## Montgomery County Humane Society Campus, Preliminary Plan 120190100

Staff Report Date: 10/5/20

Request to create one lot for 16,000 square feet of uses related to the Montgomery County Humane Society and associated parking.

Staff recommends approval of Preliminary Plan No. 120190100 subject to the following conditions:

**Figure 9: Proposed Site Access and Wide Curb Radii**

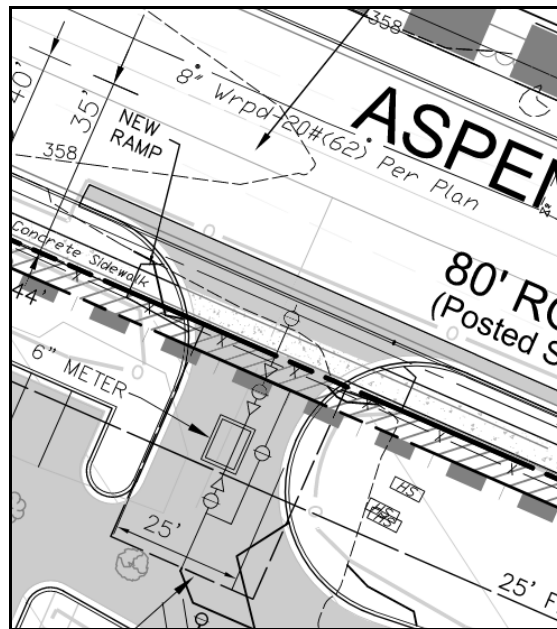
The proposed driveway curb cut is 25 feet wide at the drive aisle and 67 feet at the apron, suggesting the apron radii is excessive (see Figure 9). Staff noted these items in their coordination with the Applicant, beginning in February 2019, and coordinated with the Department of Permitting Services Fire Access team to determine whether the radii could be reduced. To improve pedestrian conditions and slow turning vehicles, staff recommends the Board condition the Applicant to reduce the driveway width

to be no greater than 22' wide and provide 15-foot curb radii at the driveway, subject to formal approval by the Department of Permitting Services' Fire Department and Access and Water Supply Division, which will need to review a revised plan prior to acceptance.

23. The certified Preliminary Plan must show the following changes:
  - a. Reduction of curb radii at the entrance to 15'.
  - b. Include the interim cross-sections for Aspen Hill Road and Georgia Avenue.
24. The Applicant must include the stormwater management concept approval letter and Preliminary Plan Resolution on the approval or cover sheet(s).
25. The certified Preliminary Plan must contain the following note:

**Figure 10: Location of Recommended Improvements**

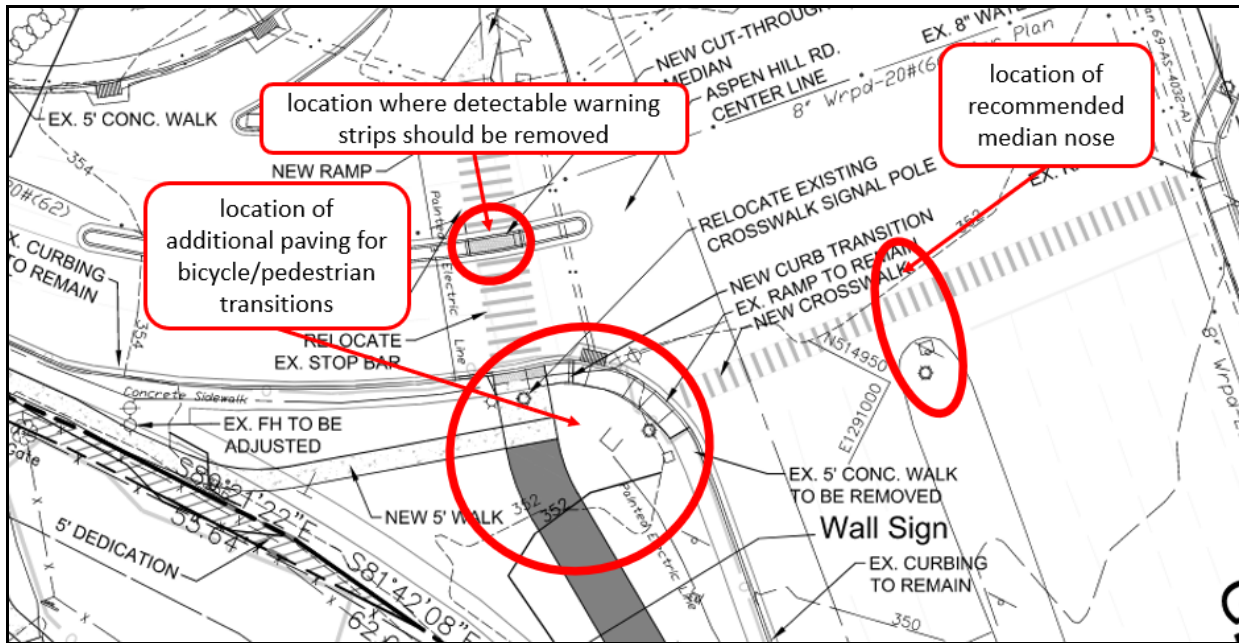
The Applicant proposes to improve the sidewalk along Aspen Hill Road to be five (5) feet wide with a six (6) foot landscape buffer. The 12-foot sidepath facility proposed along Georgia Avenue will facilitate pedestrian mobility with ample buffering along the Applicant's site frontage. The Applicant has agreed to extend the proposed sidepath past its frontage down to a logical termination point at Wendy Lane. The Applicant proposes to widen the curb ramps along the breezeway sidepath and widen the existing median break on the western leg of Georgia Avenue and Aspen Hill Road to the width of the sidepath. Because the median is less than six (6) feet wide, the existing detectable warning strips should be removed per Americans with Disabilities Act (ADA) best practices. This is because the strips indicate to an individual with visibility impairments that she or he has reached a safe location or refuge; however, the location does not provide adequate space to be considered a safe refuge (see Figure 10).

The Applicant proposes to restripe crosswalks connecting to the site as high-visibility continental crosswalks. Condition 17 requires the applicant to provide a median nose or alternate refuge facility along the crosswalk at the southern leg of the Georgia Avenue and Aspen Hill Road intersection (see Figure 10).

Based on the Applicant's plan, it is challenging to discern what treatment is proposed at the southwestern corner of Aspen Hill Road and Georgia Avenue. Condition 17 requires hardscape to provide ample room for bicycle and pedestrians to transition, dismount, turn, etc.

16. Provide a median extension on the southern leg of the Georgia Avenue and Aspen Hill Road intersection to protect pedestrians crossing Georgia Avenue, or provide an alternate form of refuge, subject to the review and approval of the State Highway Administration.

17. Remove the detectable warning strips in the median on the western leg of the Georgia Avenue and Aspen Hill Road intersection if the median is less than six feet wide, to be compliant with ADA best practices, subject to the review and approval of the State Highway Administration.

18. Provide hardscaping at the southwest corner of Georgia Avenue and Aspen Hill Road to ensure that the new proposed sidewalk and sidepath facilities can tie into the existing curb ramp with ample room for bicycle and pedestrian transitions, including the ability to turn around and dismount, subject to the review and approval of the State Highway Administration.
